### Aviation Rulemaking Advisory Committee

AGENCY: Federal Aviation Administration (FAA), DOT. ACTION: Notice of establishment of FAR/ JAR Harmonization Working Group for Propeller-Driven Small Airplanes.

Noise Certification Standards for Propeller-Driven Small Airplanes

14 CFR Part 36 Noise Certification Standards for Propeller-Driven Small Airplanes; Final Rule

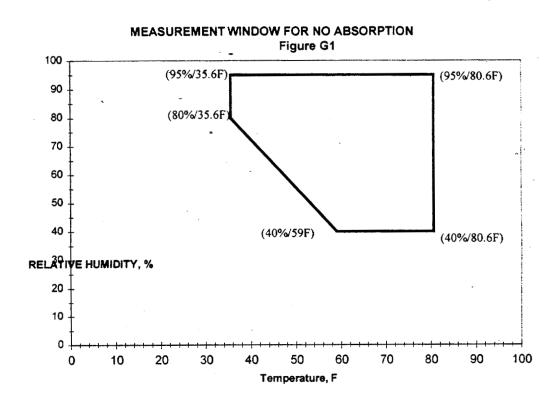
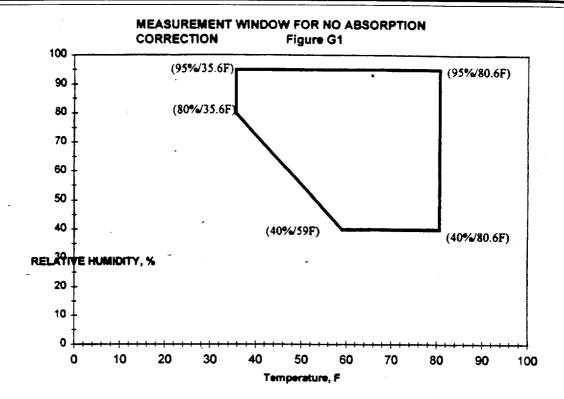
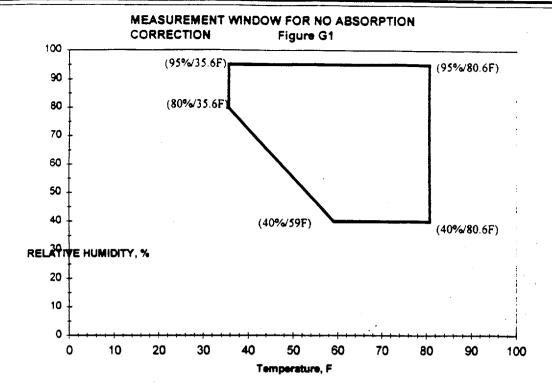
In addition to the dB(A) changes discussed, the FAA is proposing a change to the interpolation requirement of section G36.301(b). For weights greater than 1,320 pounds, the allowable dB(A) would increase "with the logarithm of airplane weight at the rate of 9.83 dB(A) per doubling of weight until the limit of 88 dB(A) is reached \* \* \*," rather than at the rate of 1 dB/ 165 pounds up to 85 dB(A) at 3,300 pounds, as under the current rule. This change would harmonize interpolation under the FAA regulation with the comparable JAA regulation without change in noise stringency of the present Appendix G.

In addition to the dB(A) increases discussed, the FAA proposed a change to the interpolation requirement of § G36.301(b). For airplane weights greater than 1,320 pounds, the allowable

dB(A) would increase "with the logarithm of airplane weight at the rate of 9.83 dB(A) per doubling of weight until the limit of 88 dB(A) is reached \* \* \*." rather than at the rate of 1 dB/ 165 pounds up to 85 dB(A) at 3,300 pounds, as under the current rule. The new logarithmic interpolation between the low and high takeoff weights was adopted from the Annex 16. Volume I Chapter 10. The working group analyzed the available data obtained by use of a ground microphone, and decided to adopt the logarithmic interpolation that is between low and high takeoff weights.

(b) The noise level must not exceed 76 dB (A) up to and including aircraft weights of 1,320 pounds (600 kg). For aircraft weights greater than 1,320 pounds, the limit increases from that point with the logarithm of airplane weight at the rate of 9.83 dB (A) per doubling of weight, until the limit of 88 dB (A) is reached, after which the limit is constant up to and including 19,000 pounds (8,618 kg). Figure G2 shows noise level limits vs airplane weight.

(b) The noise level must not exceed 76 dB (A) up to and including aircraft weights of 1,320 pounds (600 kg). For aircraft weights greater than 1,320 pounds, the limit increases from that point with the logarithm of airplane weight at the rate of 9.83 dB (A) per doubling of weight, until the limit of 88 dB (A) is reached, after which the limit is constant up to and including 19,000 pounds (8,618 kg). Figure G2 shows noise level limits vs airplane weight.

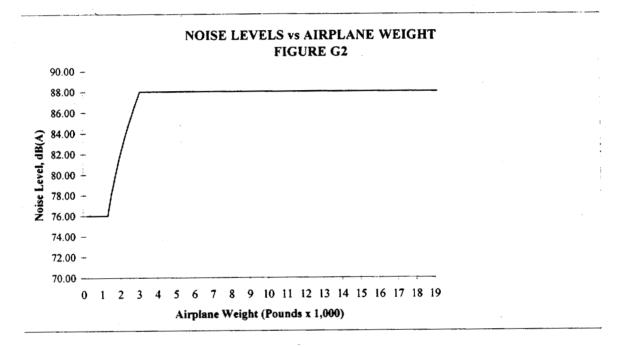
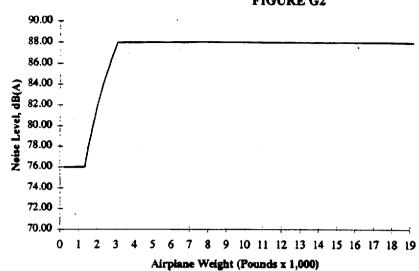
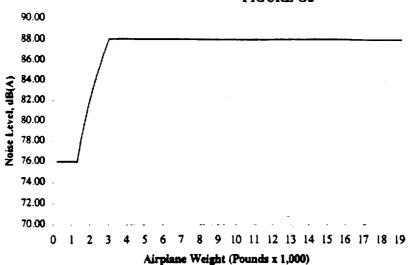
those specified in Figure G1. Noise data outside the applicable range must be corrected to 59 F and 70 percent relative humidity by an FAA approved method.

The proposed rule would amend this section by changing the atmospheric absorption correction temperatures and mathematical formulas in order to provide consistency with other sections of part 36 and to harmonize with the JAR.

Current section G36.201(b) requires atmospheric absorption correction for noise data obtained when the test conditions are outside those specified in appendix G, figure G1. Noise data collected outside the prescribed range of figure G1 are required to be corrected to 77 degrees F and 70 percent relative humidity by an FAA approved method. The FAA is proposing to change the 77 degrees F reference temperature to 59 degrees F, to be consistent with the ambient temperature requirement in current section G36.111(b)(2) that is used for performance calculations. By making the reference temperatures consistent for absorption and performance, delays and confusion that have been caused by the inconsistency in the current rule would be eliminated.

(b) Atmospheric absorption correction is required for noise data obtained when the test conditions are outside those specified in Figure G1. Noise data outside the applicable range must be corrected to 59 F and 70 percent relative humidity by an FAA approved method.

(b) Atmospheric absorption correction is required for noise data obtained when the test conditions are outside those specified in Figure G1. Noise data outside the applicable range must be corrected to 59 F and 70 percent relative humidity by an FAA approved method.
